ENVIRONMENTAL & NATURAL RESOURCES COMMISSION STAFF REPORT
Meeting Date May 19, 2025

AGENDA ITEM: St. Paul Police Training Facility, 2621 Linwood Avenue East - Wetland Buffer Variance

Motion to approve a wetland buffer variance resolution and wetland buffer mitigation strategies for the St. Paul Police Training Facility updates at 2621 Linwood Avenue East.

SHEET NAME:
SITE DEMOLITION PLAN

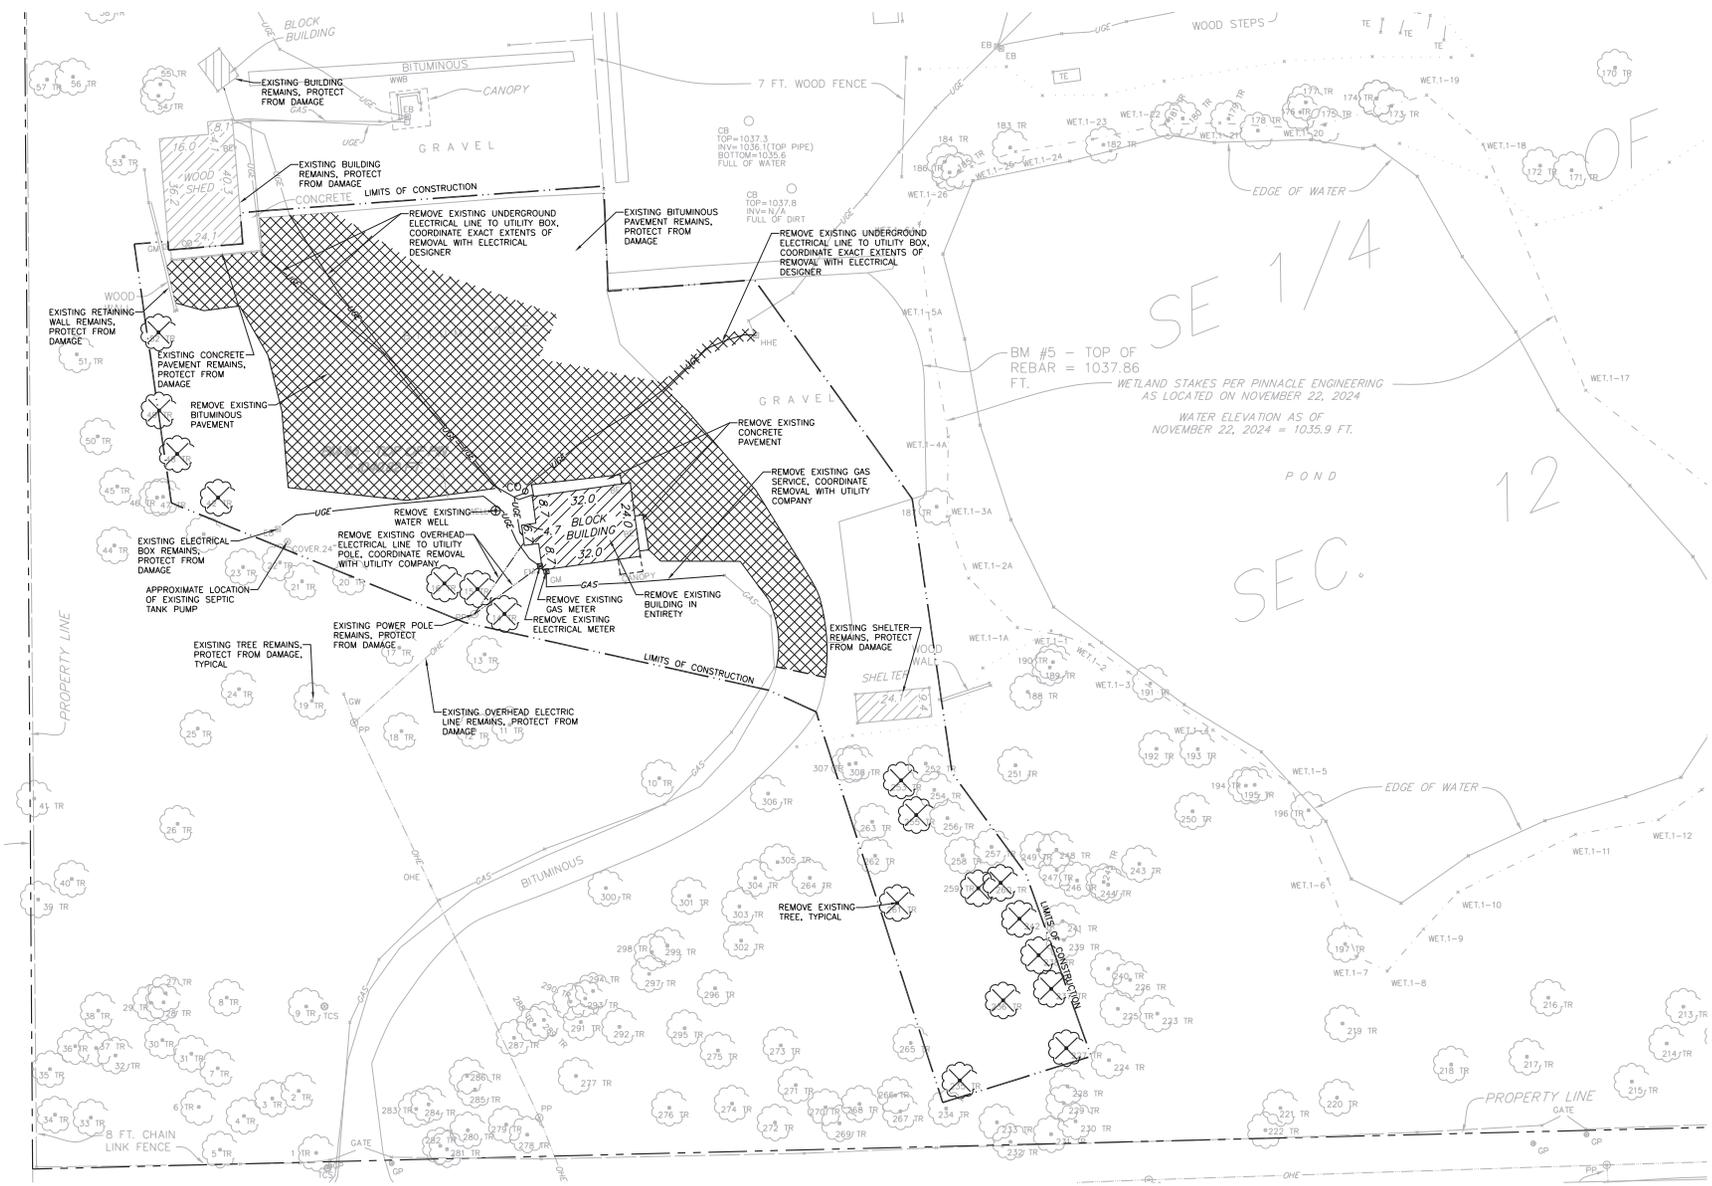
2. Tree Impacts: The tree survey identifies 308 significant trees on the site, however, the overall caliper inches of significant trees are not included. The site demolition plan shows the removal of 18 significant trees; however, the size and species of the trees are not included. Tree replacement cannot be determined without additional information, but it is likely that the tree removal is less than 20 percent of the overall caliper inches of trees on the site. In that case the required tree replacement is 18 – 2 diameter inch trees.

a) Identify which trees will be removed on the tree survey and the size and species on the site demolition plan.

SHEET NAME:
GRADING AND DRAINAGE PLAN

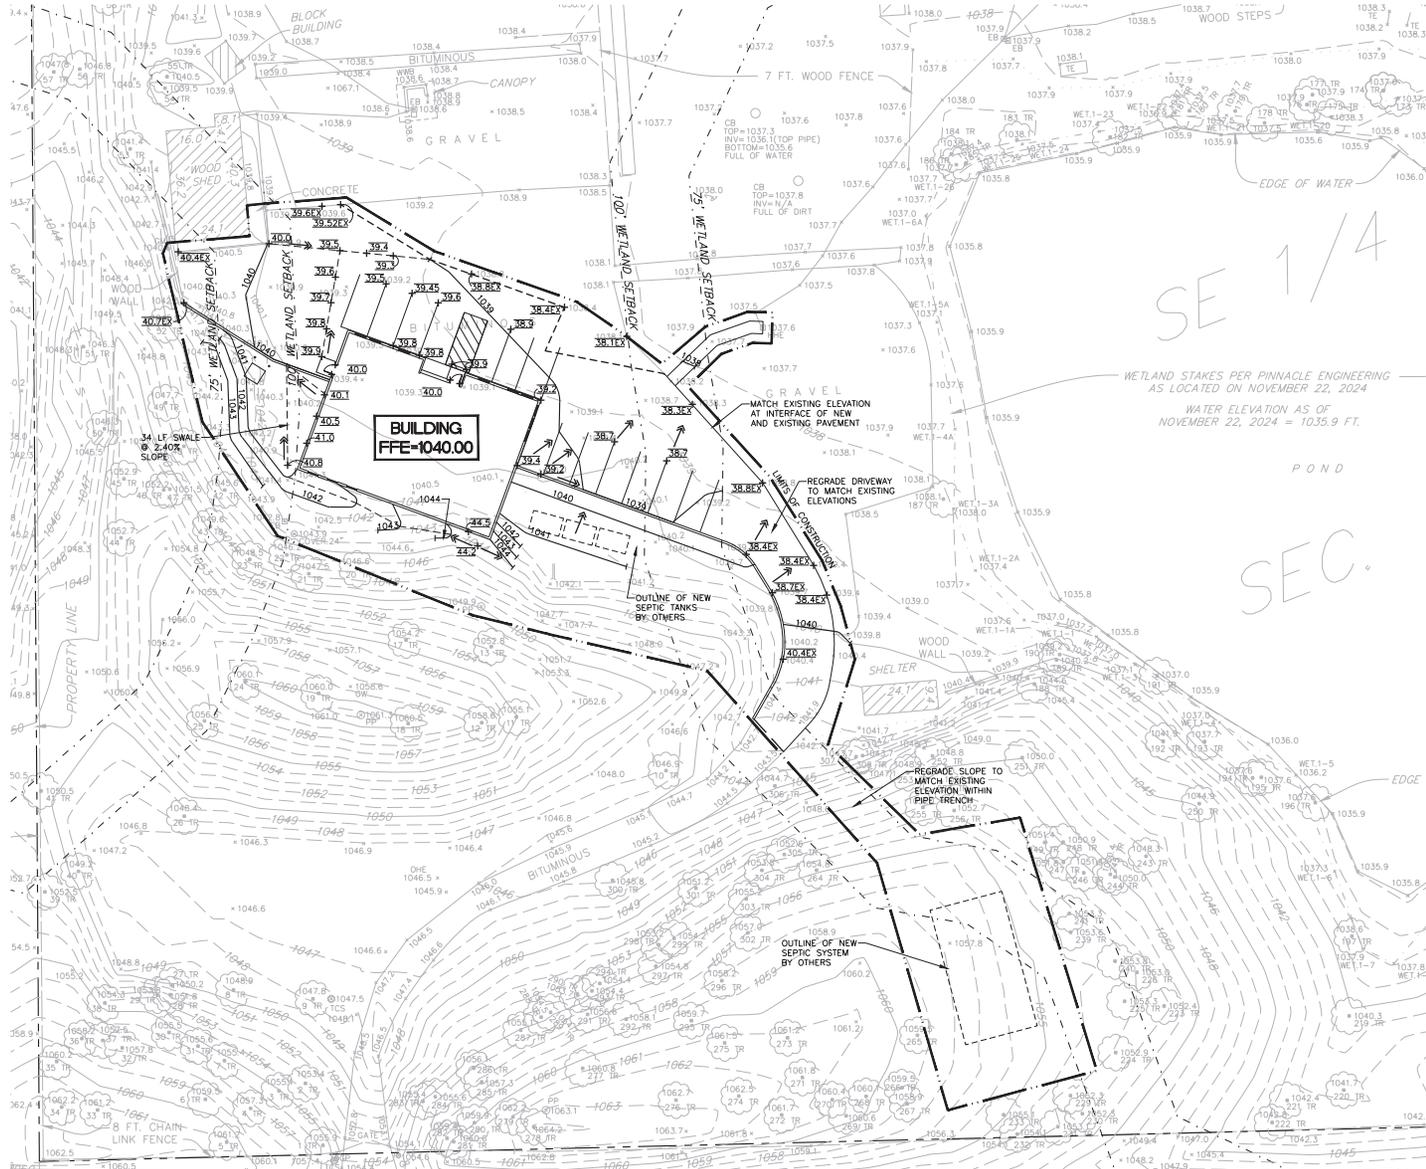
1. Wetland Buffer Impacts: The square footage of impacts within the 100-foot buffer were not included on the plans.
2. Wetland Buffer Mitigation: The square footage and wetland buffer mitigation strategies are identified on the removal and restoration plan. The applicants are proposing a total of .15 acres of wetland buffer mitigation as follows -

Zone 1A:

- .06 acres located on the north side of the eastern wetland.
- Remove and treat all buckthorn, honeysuckle, and Japanese knotweed.

Zone 1B:

- .02 acres located on the south side of the eastern wetland.
- Remove and treat all buckthorn, honeysuckle, and Japanese knotweed.

Zone 2:

- .05 acres located on the east side of the eastern wetland adjacent the Class 5.
- Remove and treat all Japanese knotweed and reed canary grass.
- Seed with wetland edge seed mix.
- Plant wetland edge native plugs, 24 inches on center.

Zone 3:

- .02 acres of Class 5 being removed along the eastern wetland.
- Remove four dead ash trees.
- Remove gravel and replace with topsoil.
- Seed with mesic prairie seed mix.
- Plant Mesic native plugs, 24 inches on center throughout.

SHEET NAME:
LANDSCAPE PLAN

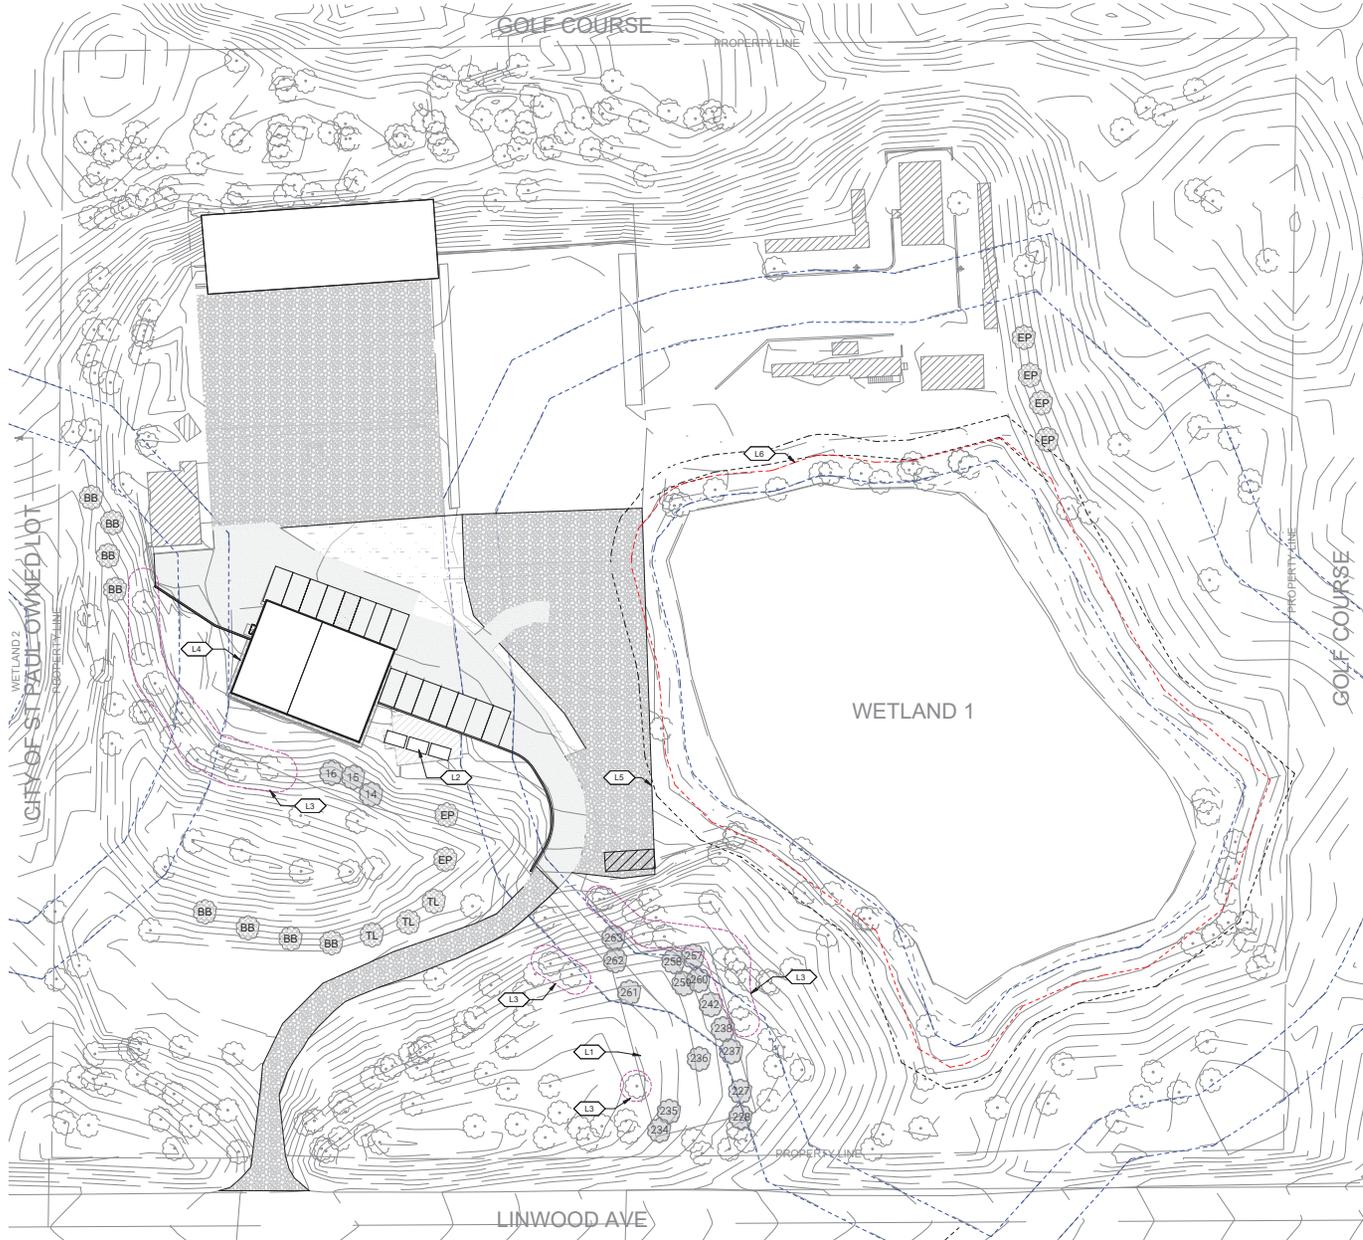
3. Tree Replacement: The landscape plan includes 18 – 2 diameter inch trees.

- a. Prior to issuance of a grading permit the following is required:
 - 1) Fence plan to include the materials, height, and location.
 - 2) Revised landscape plan to include:
 - a) Detailed plan for nonnative plant removal and maintenance.
 - b) Native seed mix to be installed in the area called out as Zone 1A in the May 5 restoration plan in addition to the proposed removal of the nonnative plants.
 - c) Detailed plan for new wetland buffer including seed mix species and installation methods, and location and species of native plant plugs.
 - d) Final landscape plan to be reviewed and approved by the Natural Resources Coordinator.
